Subject: 10CFR21 Reporting of Defects and Non-Compliance -  
Engine Systems, Inc. Report No. 10CFR21-0118, Rev. 0

Speed Switch  
PNs ESI50267C, ESI50267E, ESI50267H, and ESI50267K

**Report No. 10CFR21-0118**

**10CFR21 REPORTING OF DEFECTS  
AND NON-COMPLIANCE**

Photo 1: View Showing Capacitors C1 through C8

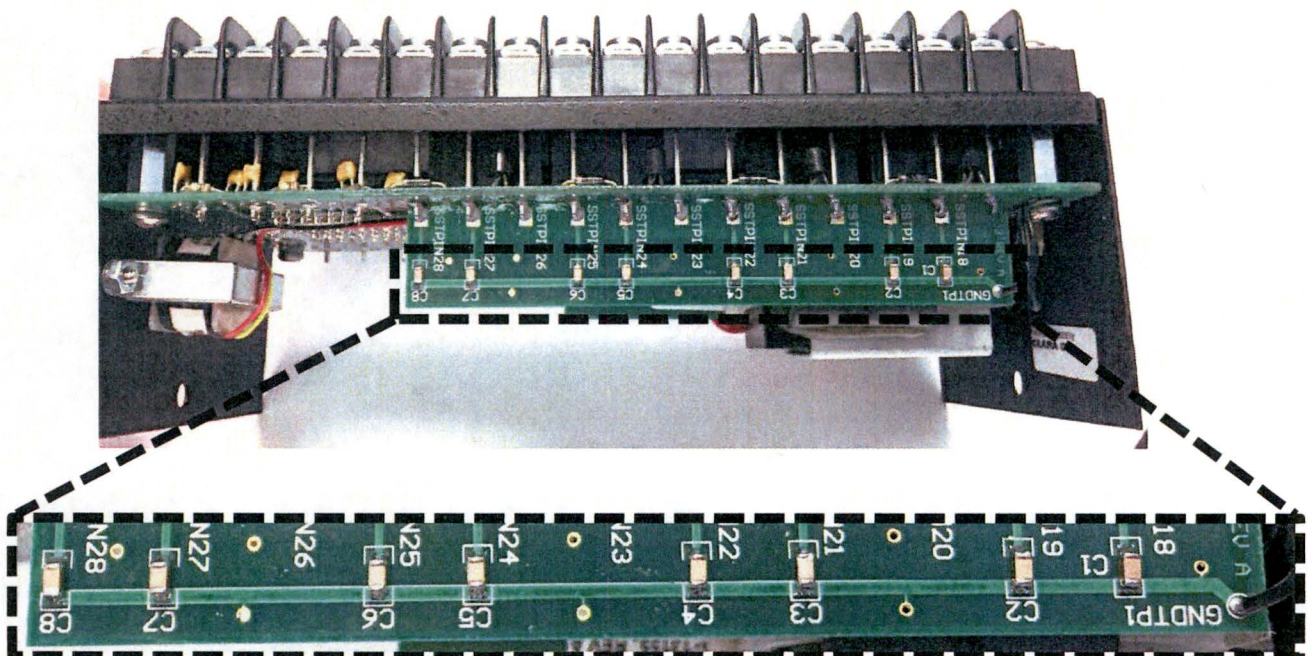
This speed switch design is fully EMC compliant in accordance with EPRI TR-102323, rev.3. In order to meet the EMC requirements, some design modifications were made during the EMC qualification. One of these modifications was the addition of eight (8) capacitors, C1 through C8, installed from Normally Open-to-Ground and Common-to-Ground for the speed switch's relay output contacts (the switch has four relays). See Photo 1 below and Figure 1 on the following page showing location of capacitors. The modifications utilized for EMC compliance were incorporated into the speed switch design by the OEM and offered as a unique part number SST2400A-416.

The failed speed switch at Hope Creek was sent to Exelon PowerLabs for analysis. It was determined that capacitor C4 (terminal 22 to ground) had degraded and exhibited a low-resistance path to ground. Capacitor C4 is rated for 200 VDC working voltage and has a withstand voltage of 500 VDC. Further investigation revealed that although the nominal system voltage is 120 VDC, the customer's external relay coils that are connected to the speed switch output contacts do not have transient suppression, such as with a flyback diode. In these cases, the voltage transient produced when de-energizing the relay's coil is large enough to damage the capacitors. Hope Creek recorded a voltage spike exceeding 1467 VDC.

- (1) For those customers that have transient suppression across the associated relay (i.e. VSR or ESR relays at the Exelon plants), there is no negative impact. The speed switch will operate properly in this system.
- (2) For those customers that do not have transient suppression across the associated relay (i.e. CRR, ASR, LSR, and HSR at Hope Creek), this speed switch design is not appropriate for their system. Any speed switch(es) that are installed should be removed from service.
- (3) ESI is currently evaluating options for re-designing the speed switch while maintaining the EMC compliance desired by many customers. This evaluation is underway and is expected to be complete within 60 days.

Figure 1: Schematic Representation of Capacitors Installed on Relay Output Contacts

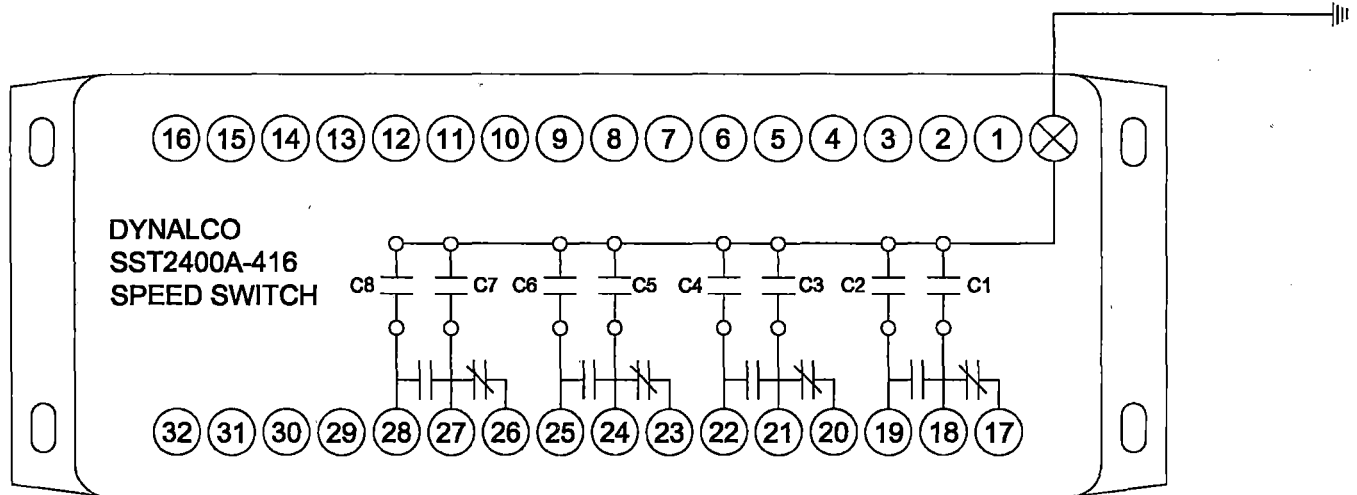
For customers that have flyback diodes or a similar transient suppression device across the external relay coil, there is no issue. However for customers without such protection, the magnitude of the voltage transient may be sufficient to damage and degrade the capacitor to the point of a low resistance path to ground.

The root cause of the failure is a deficiency in the design and selection of the EMC mitigating components. Consideration was not given for the impact of voltage transients imparted on the capacitors during coil de-energization. For customers without suppression from the inductive kick, the magnitude of voltage transients may be sufficient to damage and ultimately degrade the capacitors to the point of failure.
